**Statement of Response
to An Bord Pleanála
Opinion**

Proposed SHD Planning Application

**At Glenamuck Road North,
Carrickmines,
Dublin 18**

**On behalf of
Moran Park Homebuilders Ltd.**

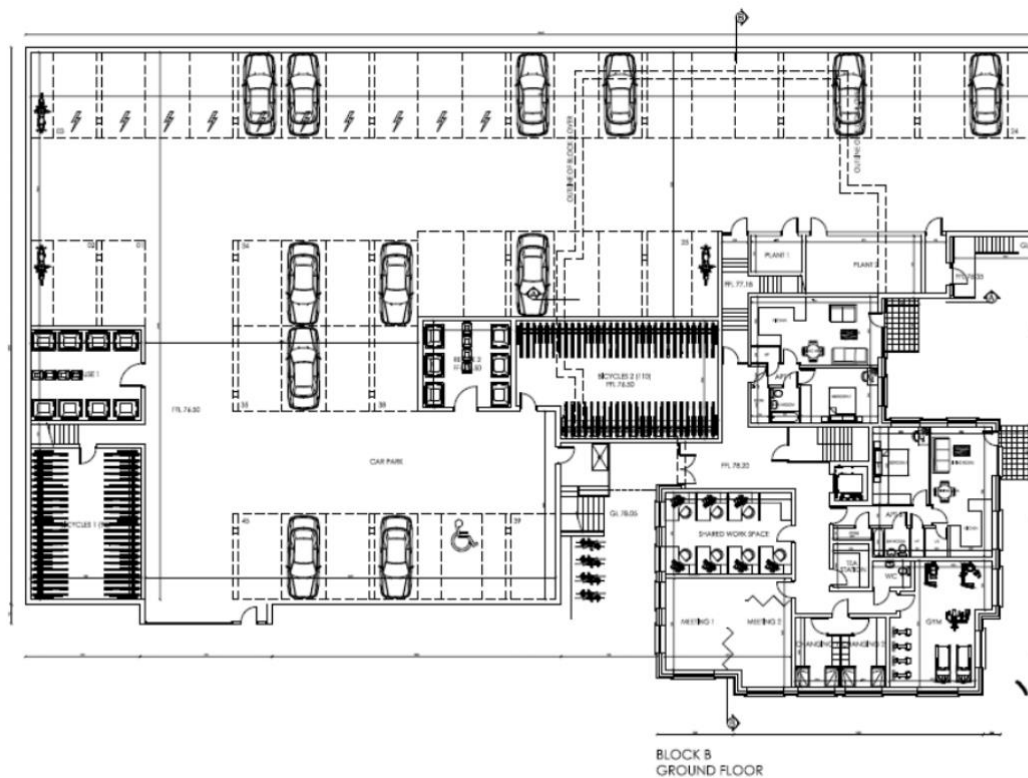
(a) Proposed works at Glenamuck Road North as proposed traffic management measures.

A full and comprehensive Construction Traffic Management Plan and proposals shall be prepared by the appointed contractor for the works at Glenamuck Road North. These shall be agreed with the local authority Transportation, Roads and Maintenance departments as required, in advance of the commencement of works.

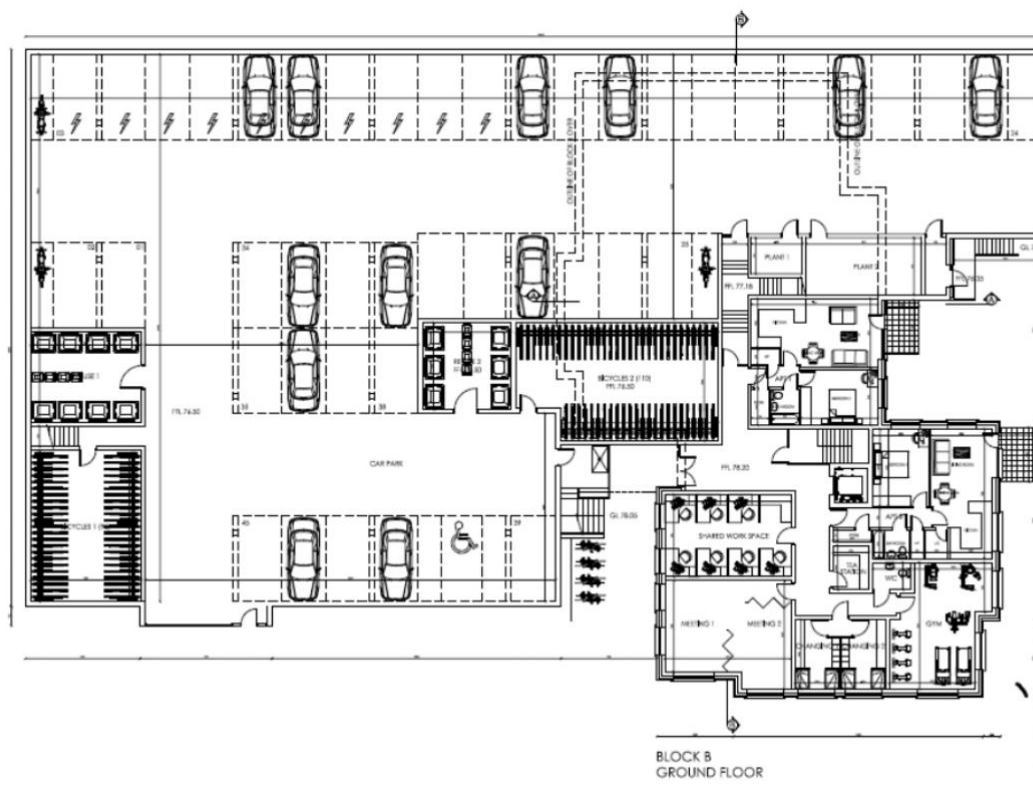
6. In accordance with the County Development Plan Policy ST27: Traffic Noise ‘the effect of traffic noise on new development must be considered and appropriate measures undertaken to mitigate same.’ The applicant shall show what mitigation measures (if any) will be provided in order to keep noise within the development to acceptable levels i.e., boundary treatment, and double/triple glazing etc.

The proposed boundaries shall provide for a solid 600mm wall and 1200mm railing to the west, north and south of Blocks A&B and to the west of Block C. The solid wall shall provide an element of sound proofing. The railings chosen to provide security and allow light into the ground floor units. The proposed boundary treatment, therefore, would have a limited impact on sound proofing but would provide the amenity and security required for a development such as this.

Defensive planting and the planting of trees shall provide a limited level of sound proofing. It shall protect the lower ground floor from visual impact of traffic. Solid boundaries and high planting is not preferred adjacent to the buildings as the passive supervision of exterior spaces and light would be greatly reduced.
